R22BX

DATE: October 24, 2023
TO: Blue Bird Owners
Subject: R22BX: Roush Zinc Plated Return Line Fittings

SUBJECT: R22BX: Roush Zinc Plated Return Line Fittings

Gen 4 and 5 Blue Bird Vision - Return Fuel Line Removal and Replacement Instructions

Preparing New Return Fuel Line for Installation

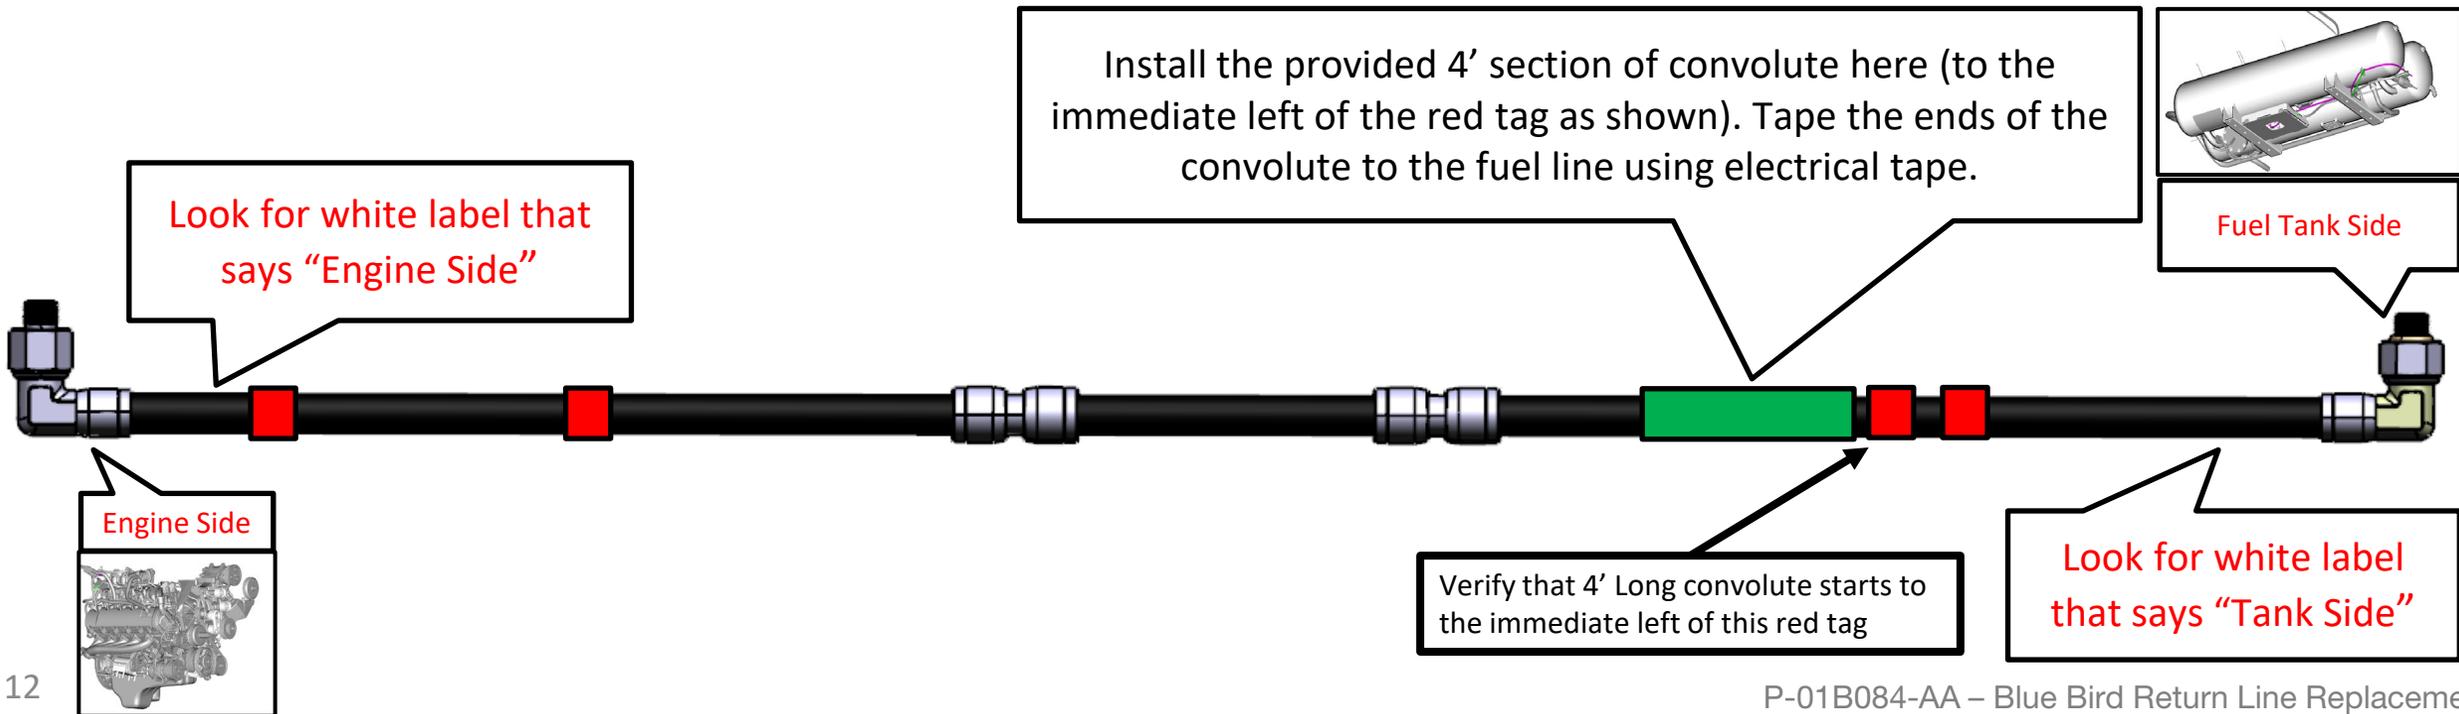
1. Verify that the new Return Fuel Line appears as shown in the image below (**Gen 4 only**).
2. **Do not** remove the plastic coverings from the end fittings until the time comes to install these fittings into their designated locations on the vehicle (as described in this manual). These coverings protect the fuel line from internal contamination during the installation process.
3. Pre-install provided 4' Long Convolute (P/N PLS-34-100-B-1219) to the fuel line at the indicated location. Retain the ends of it in place with electrical tape. The tape will ensure that the convolute stays in position during fuel line installation.

Preparing New Return Fuel Line for Installation

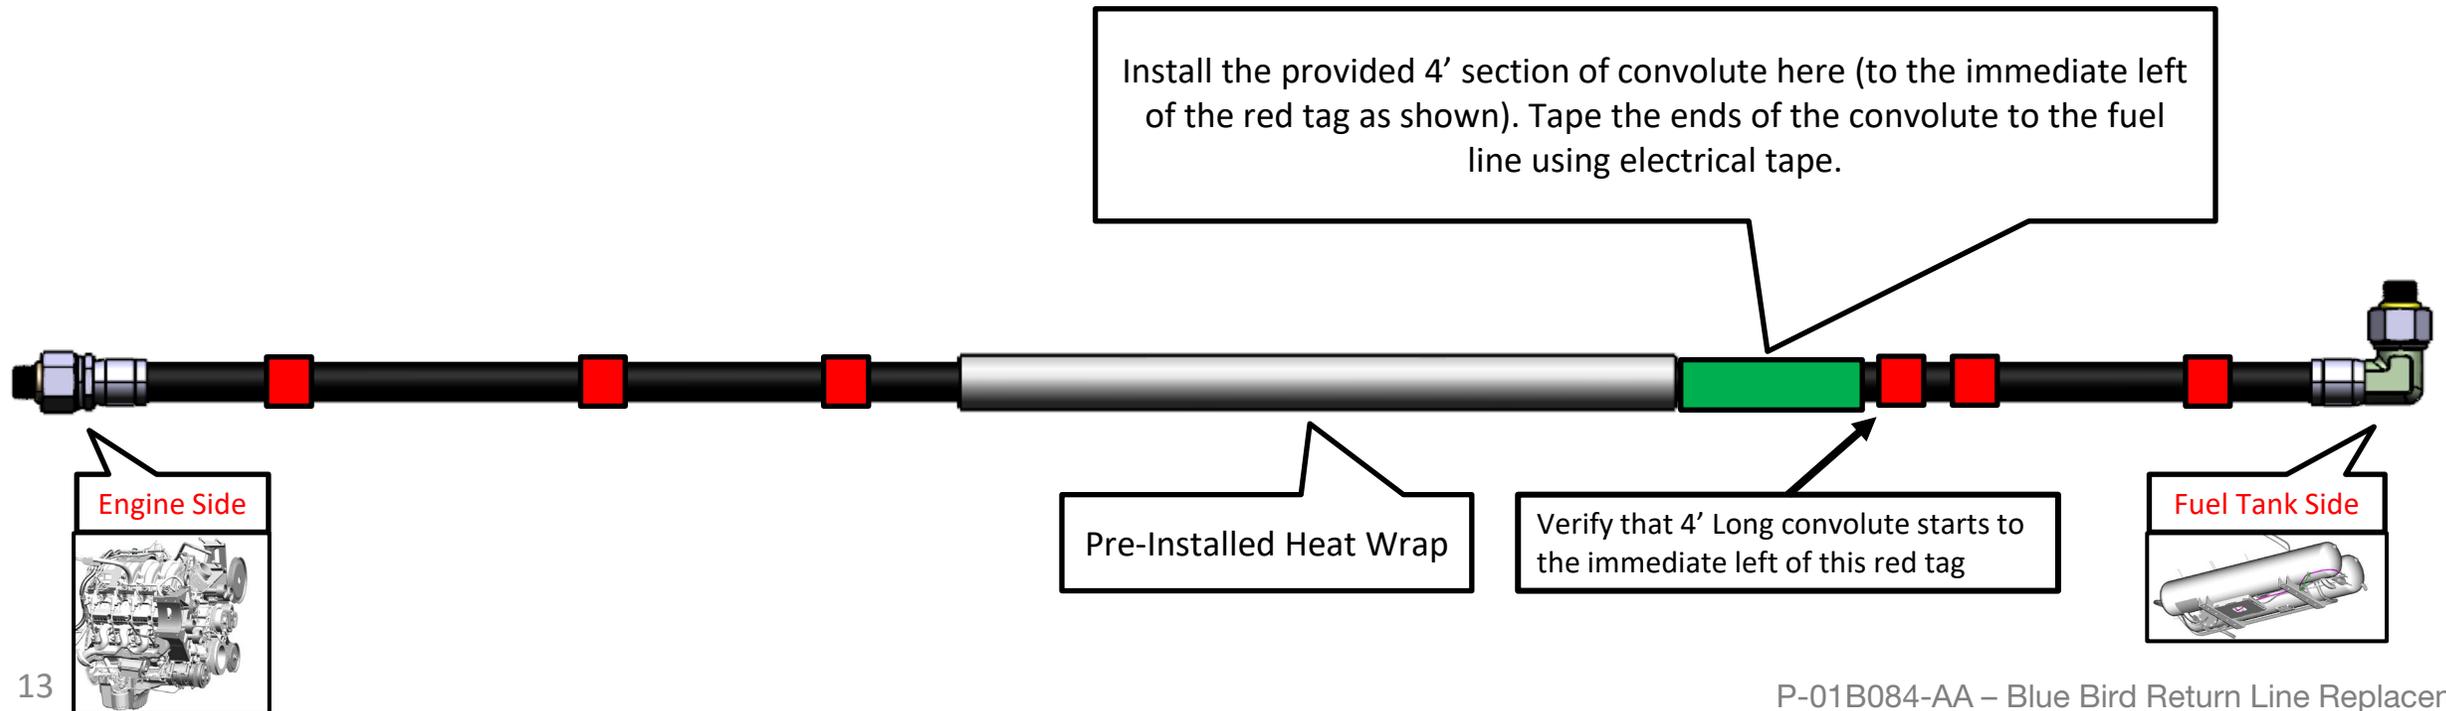
1. Verify that the new Return Fuel Line appears as shown in the image below (**Gen 5 only**).
2. **Do not** remove the plastic coverings from the end fittings until the time comes to install these fittings into their designated locations on the vehicle (as described in this manual). These coverings protect the fuel line from internal contamination during the installation process.
3. Pre-install provided 4' Long Convolute (P/N PLS-34-100-B-1219) to the fuel line at the indicated location. Retain the ends of it in place with electrical tape. The tape will ensure that the convolute stays in position during fuel line installation.

Installation of the Return Fuel Line at the Engine

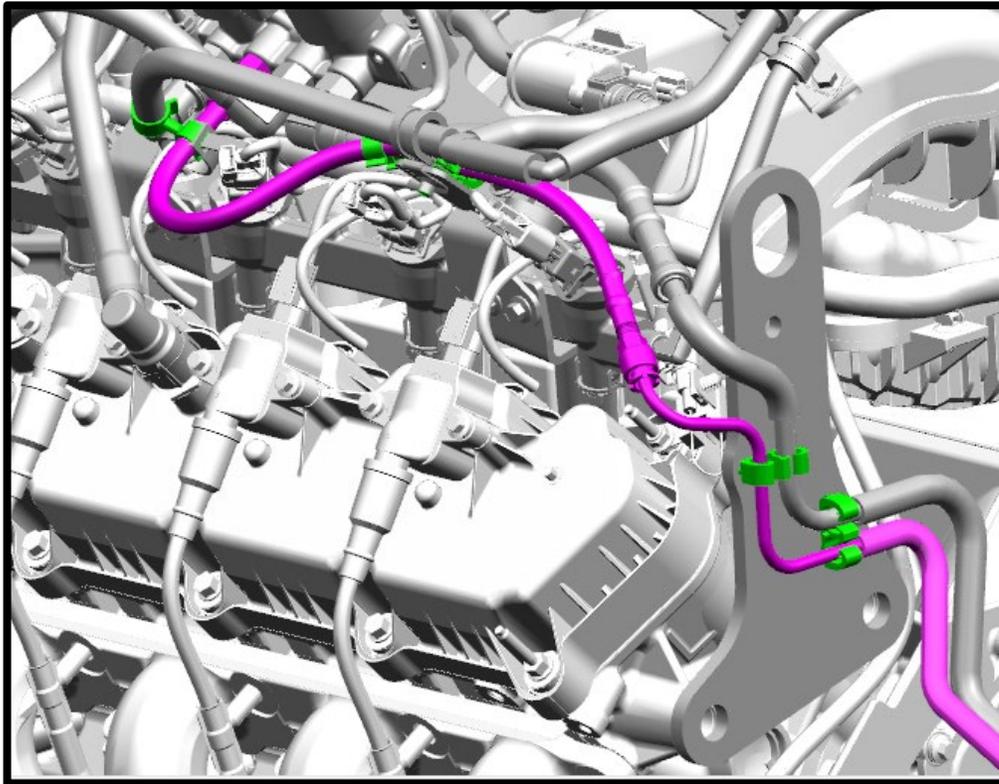
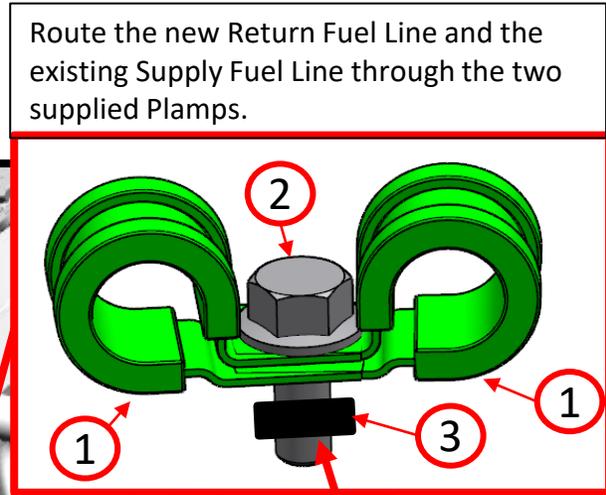
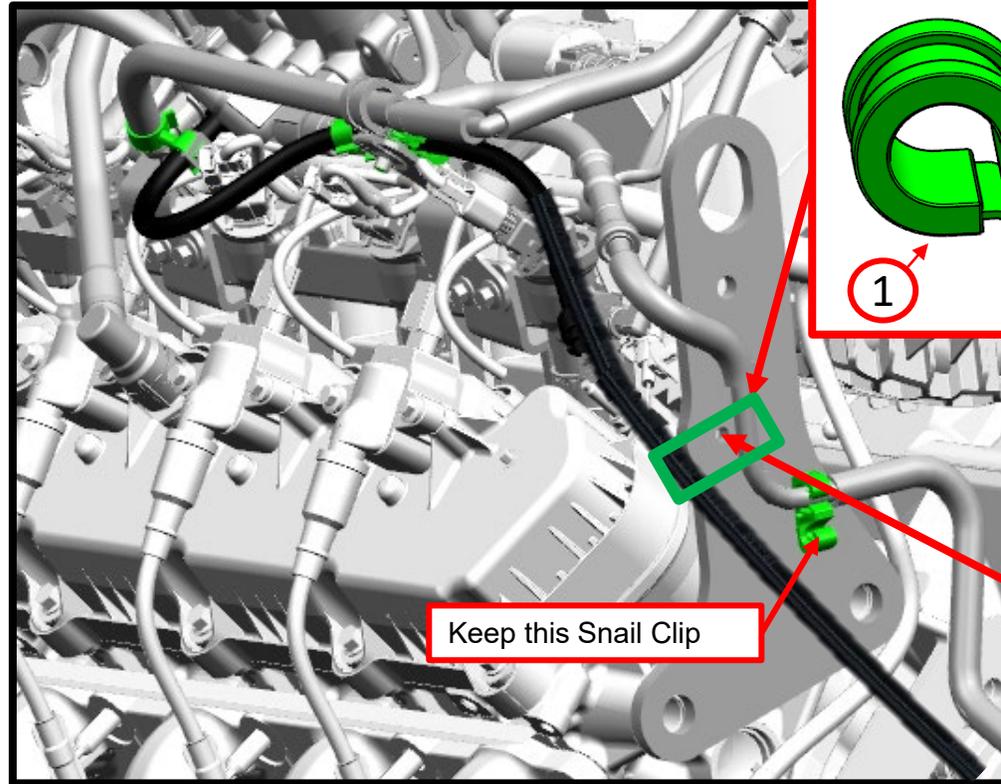
BEFORE NEW RETURN FUEL LINE

AFTER NEW RETURN FUEL LINE

Remove the original snail clip that was positioned here. Mount Plamps to the engine lifting bracket using the indicated hole.

Just behind the engine, remove the existing snail clip and use two Plamps to retain the existing Supply Fuel Line and the new Return Fuel Line. **A red tag on the return fuel line will indicate the proper location to clamp the new fuel line in place.**
